## Proposal for a Selective Self-test

Pete McLean  
 Maxtor Corporation  
 2452 Clover Basin Drive Longmont, CO 80501  
 303 678-2149

15 February 2002

Modifications to ATA/ATAPI-6 revision 3a:

**Figure xx – Selective self-test test span example**

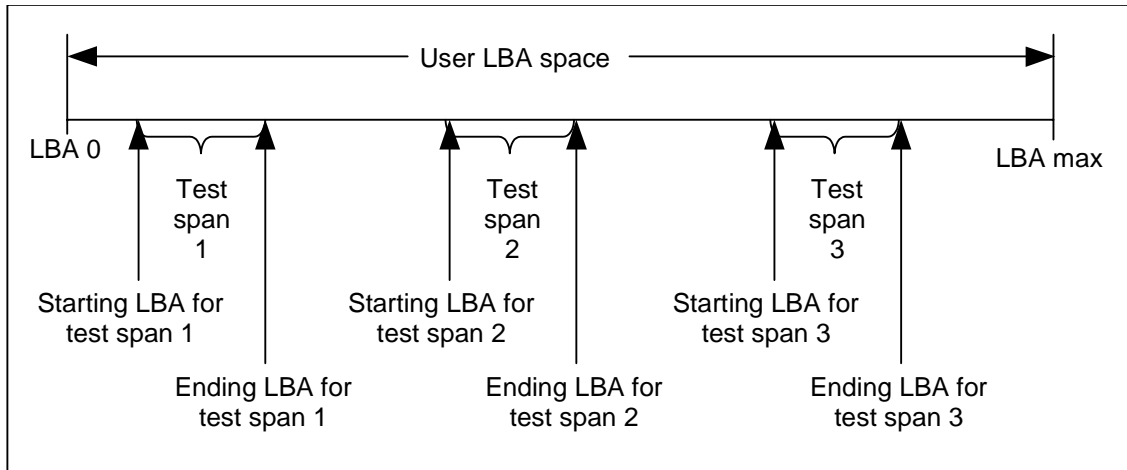
The user may choose to do read scan only on specific areas of the media. To do this, user shall set the test spans desired in the Selective self-test log and set the flags in the Feature flags field of the Selective self-test log to indicate do not perform off-line scan. In this case, the test spans defined shall be read scanned in their entirety. The Selective self-test log is updated as the self-test proceeds indicating test progress. When all specified test spans have been completed, the test is terminated and the appropriate self-test execution status is reported in the SMART READ DATA response depending on the occurrence of errors. Figure xx shows an example of a

Selective self-test definition with three test spans defined. In this example, the test terminates when all three test spans have been scanned.
